ADDENDUM NO. 2

FEBRUARY 28, 2024

Staunton City Public Schools, VA
Shelburne Middle School Additions and Renovations
CRA Project No. 3636

PLUMBING ENLARGED NEW WORK
PLAN

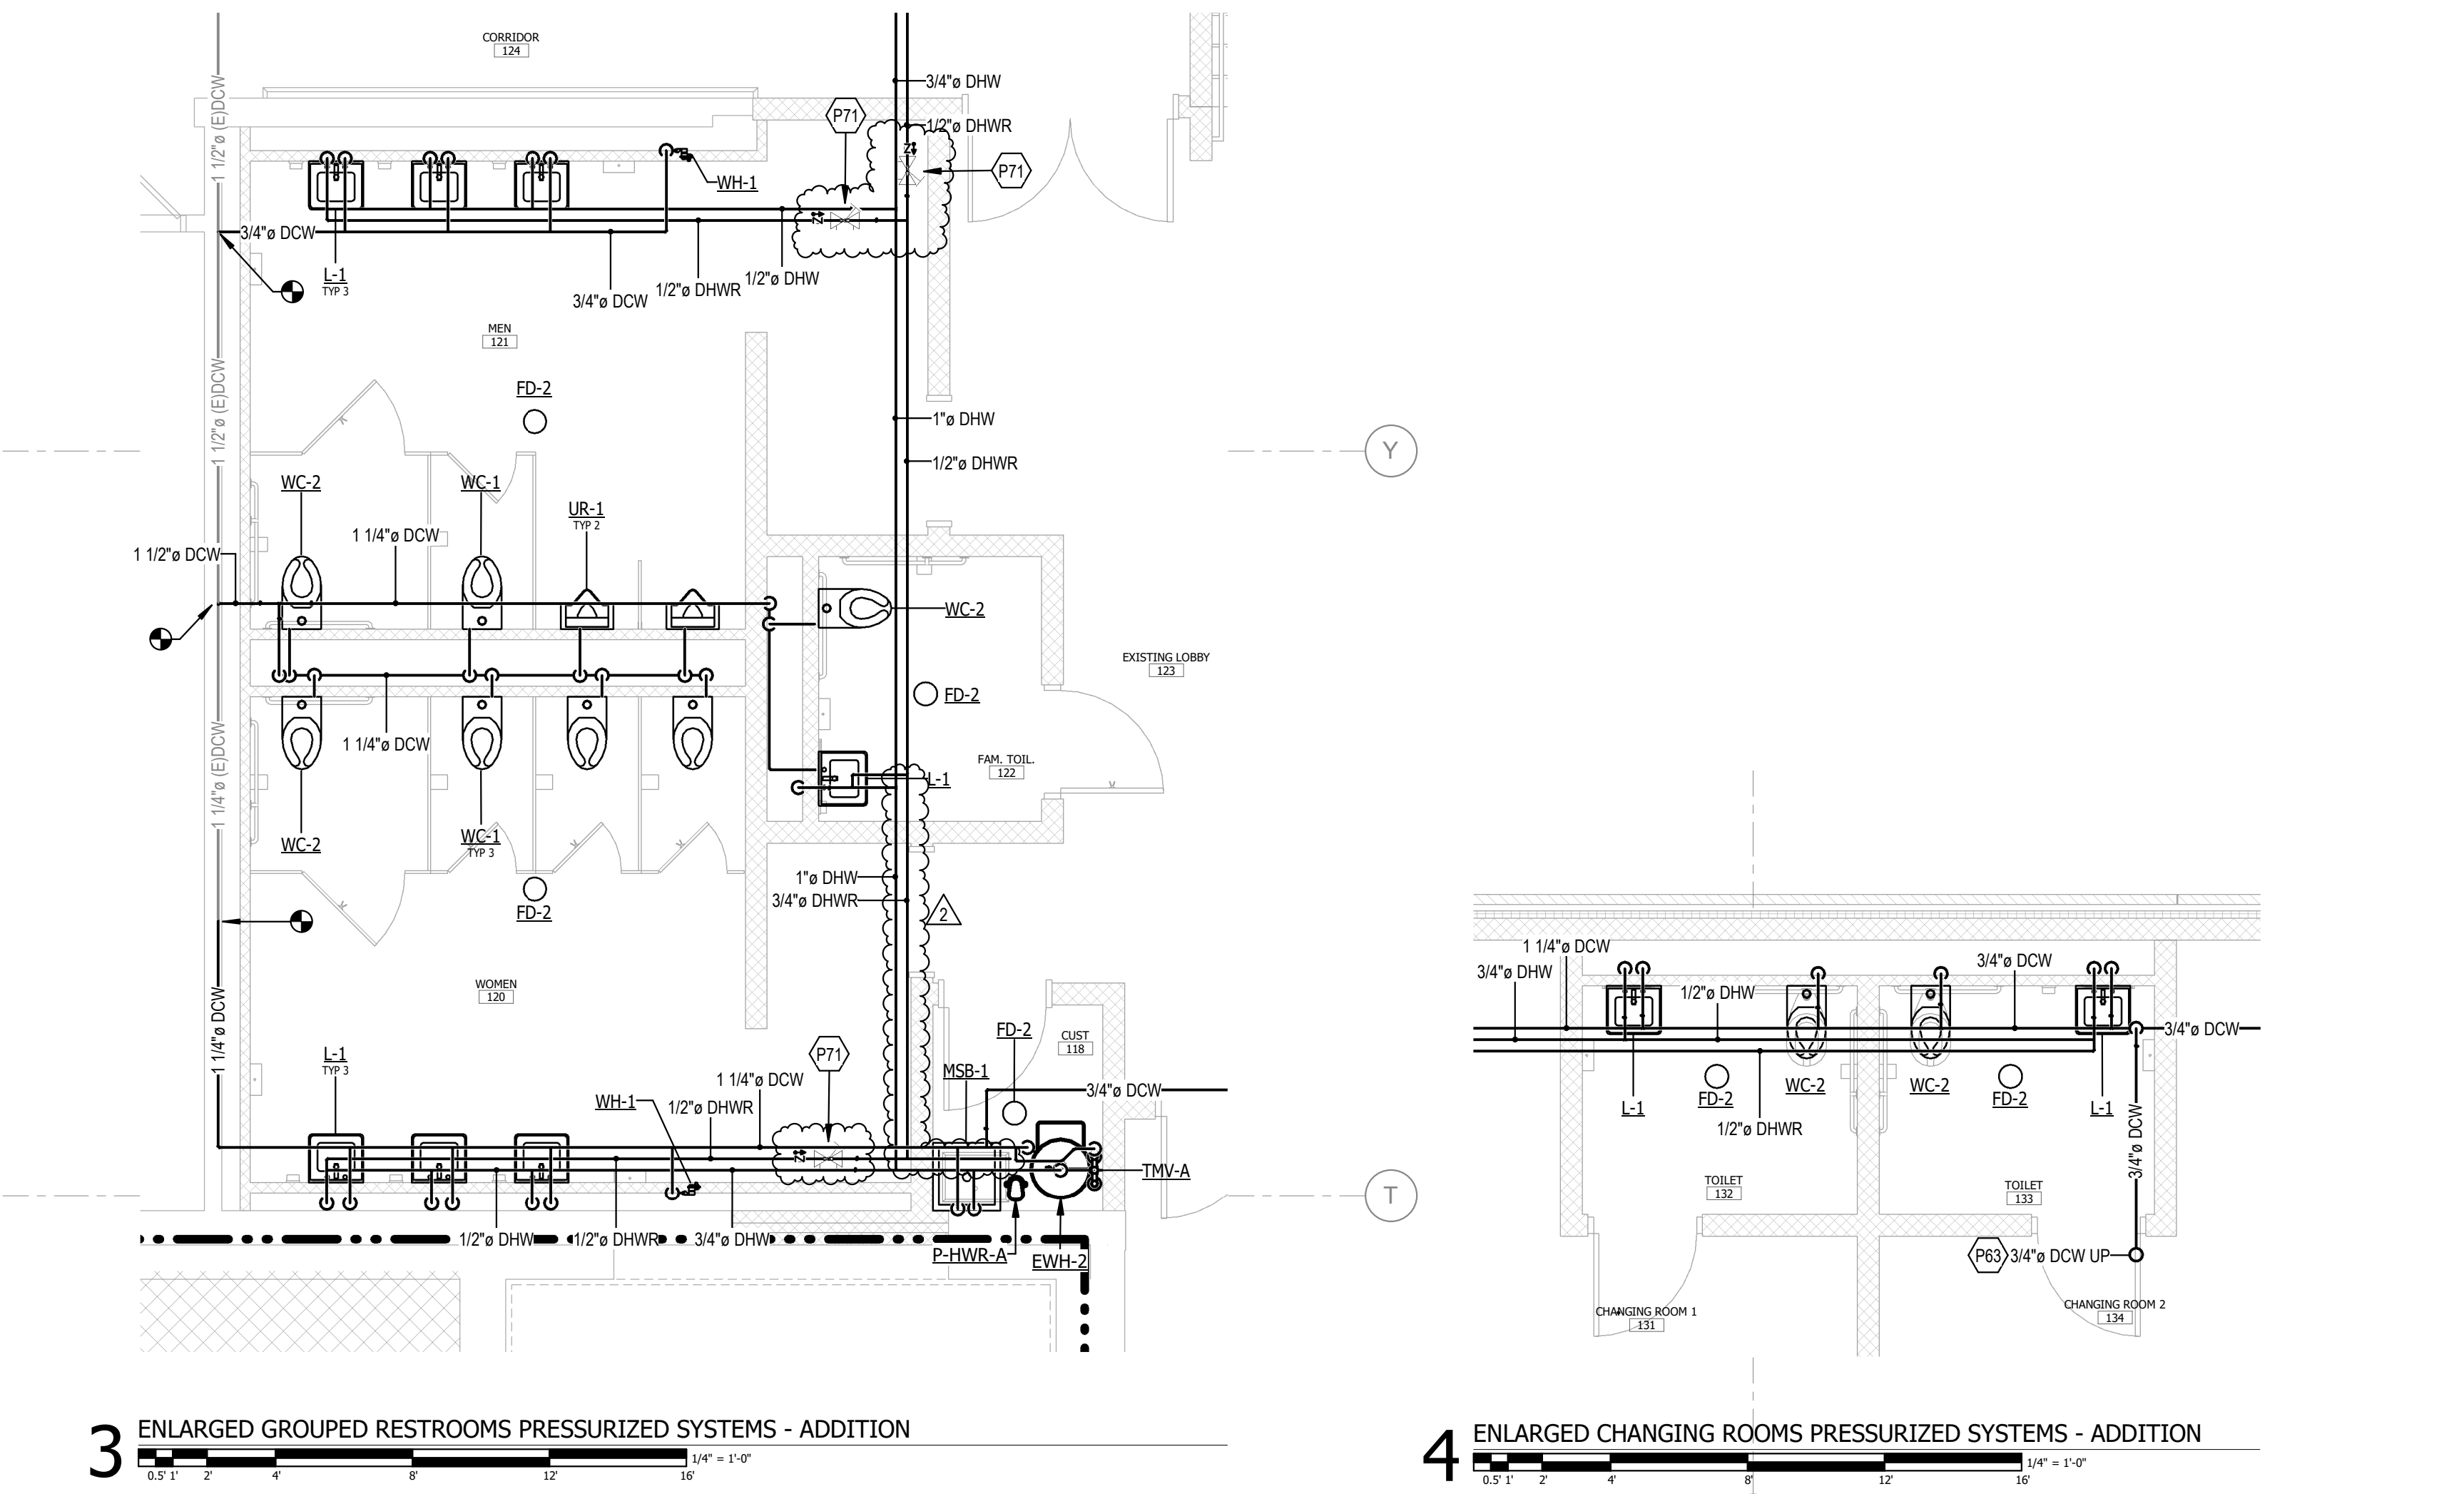
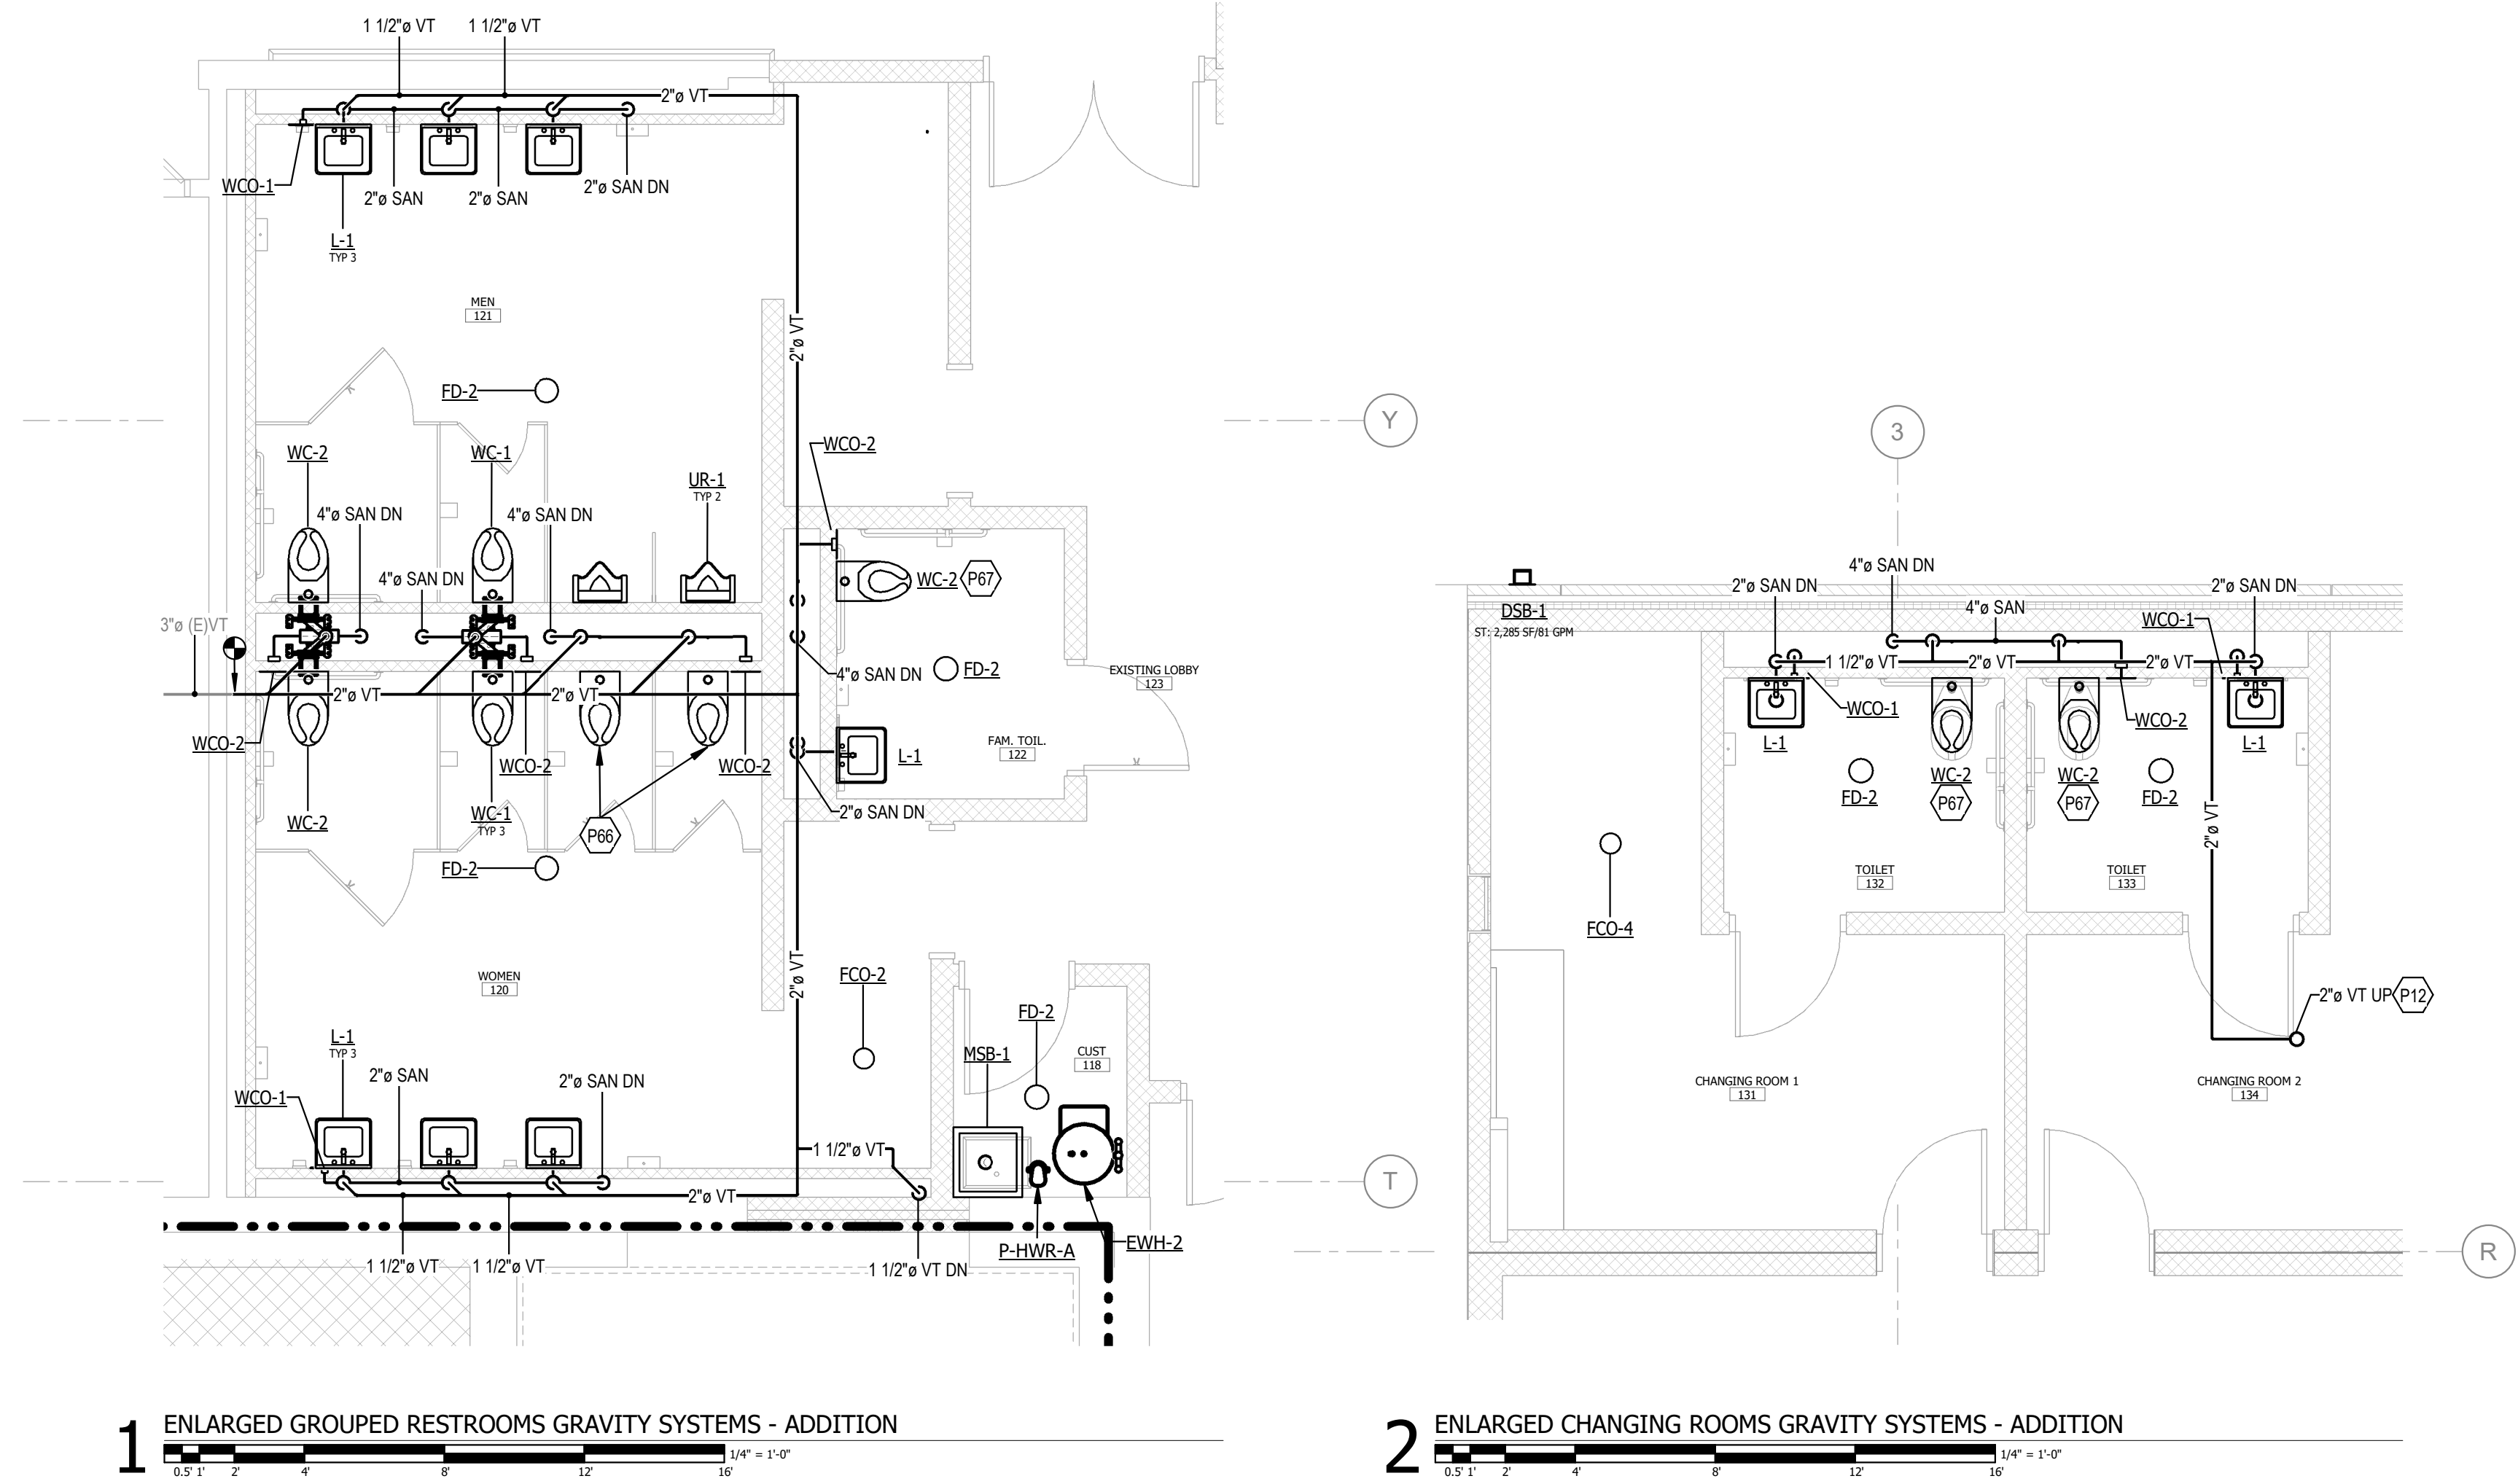
1. **DELETE** this sheet in its entirety and **REPLACE** with the attached sheet.
 - a. **ADD** three (3) balancing valves, three (3) check valves and three (3) ball valves to the DHWR branches above the group restroom area.
 - b. **REVISE** the last twenty (20) feet of DHWR piping to be sized at $\frac{3}{4}$ " in lieu of $\frac{1}{2}$ " above the grouped restroom.
